Risk Assessment Methodology Development for Waste Isolation in Geologic Media

Technical Review of Documents NUREG/CR-1262, NUREG/CR-1376,
NUREG/CR-1377, NUREG/CR-1397, and NUREG/CR-1608

Science Applications, Inc.

Prepared for
U. S. Nuclear Regulatory
Commission

Figure 3-3. Geology and Model Grid for RRS in Bedded Salt.

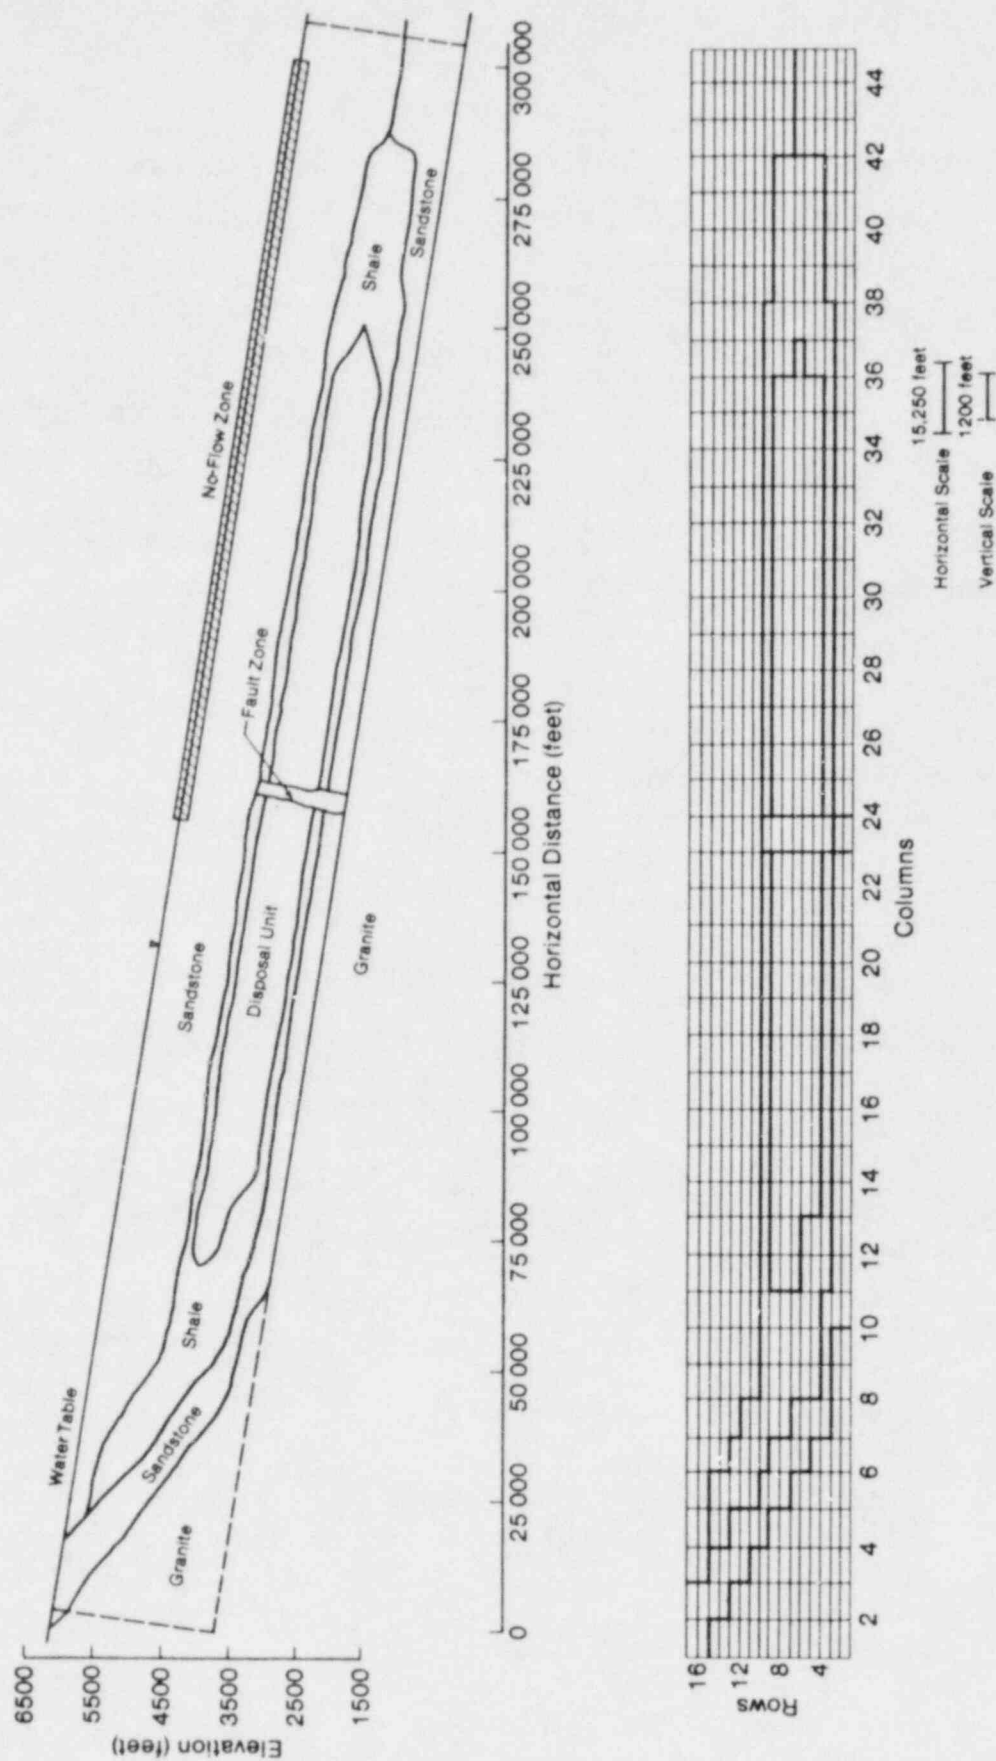
The CGS geologic model in bedded salt (NUREG/CR-1608, Report 5; Figure 2.1 shown here as Figure 3-3) is quite similar to the model used in Campbell et. al. (NUREG/CR-0458; Figures 1.2.2 and 3.3.3 shown here as Figures 3-4 and 3-5). The differences are in the shape of the shale-sandstone front end in Figure 3-3 occurring in the 25,000-50,000 ft. horizontal distance region. Figure 3-4 shows this region as shale with a lower stratum of sandstone. The Sandia work shows a sand and gravel and upper shale cap while the CGS model assumes a no-flow zone. The CGS model shows no lower river, however, and seems to treat a release from the host rock as a release to the environment. The way CGS treats this is somewhat confusing. Paragraph 3 page 9 of Report 5, states that the sides and bottom are

no-flow boundaries. Figure 2.3 shows that half of the upper boundary is a no-flow boundary. The same paragraph states that ground water can only enter or leave through the upper boundary where heads are assigned. The Sandia scenario is understood to consider groundwater migration to the lower river which couples to the biota.

Figure 3-4. Geologic Cross Section at Reference Site (Vertical Exaggeration X20).

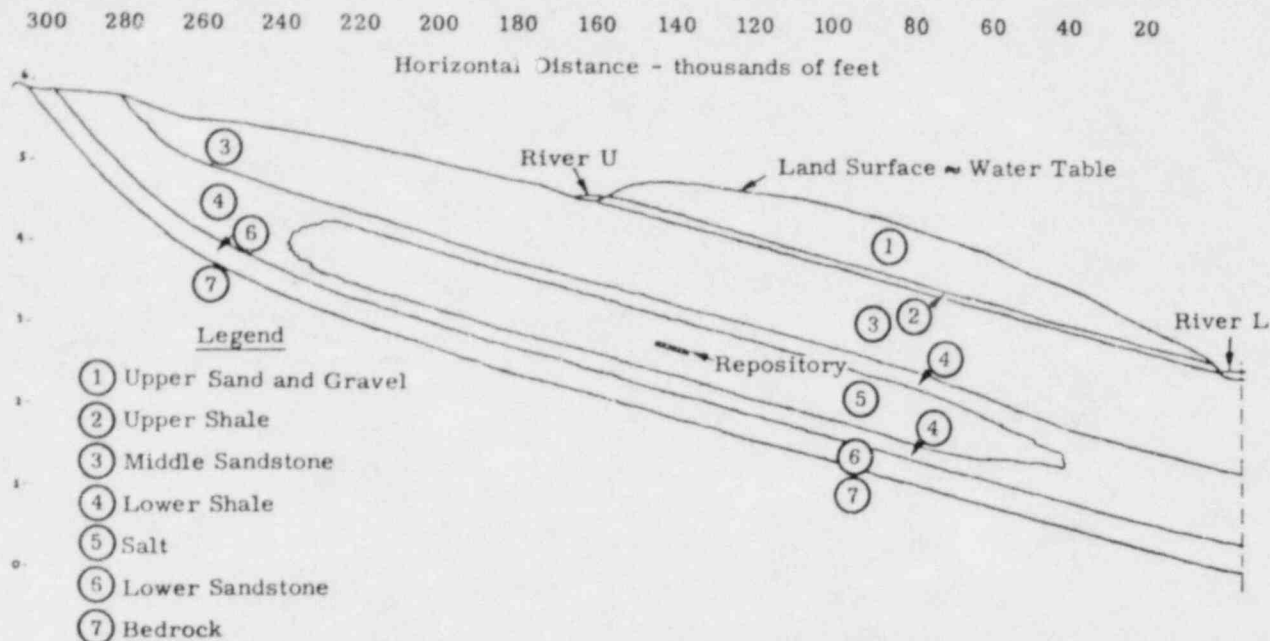
Page 19. In Figure 3, "Vertical Exaggeration x 20" cannot be correct. Why doesn't Figure 3 have a vertical scale?

Figure 3-5. Reference Site as Gridded for Transport Calculations.

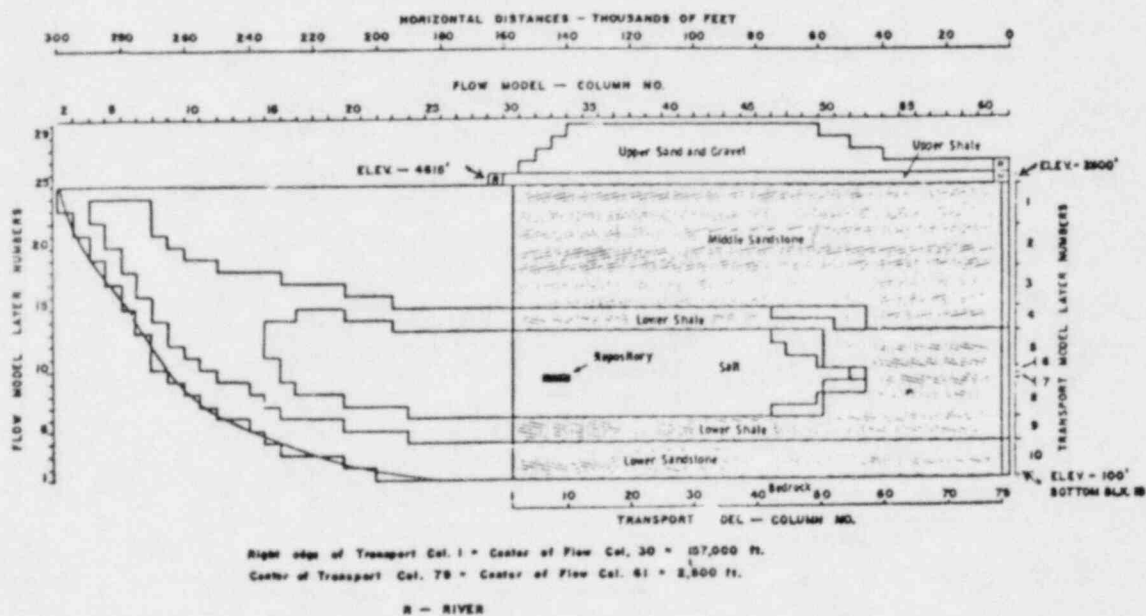
Page 22. Figure 5, does the size of arrows have any significance as to the magnitude of the velocity vectors?
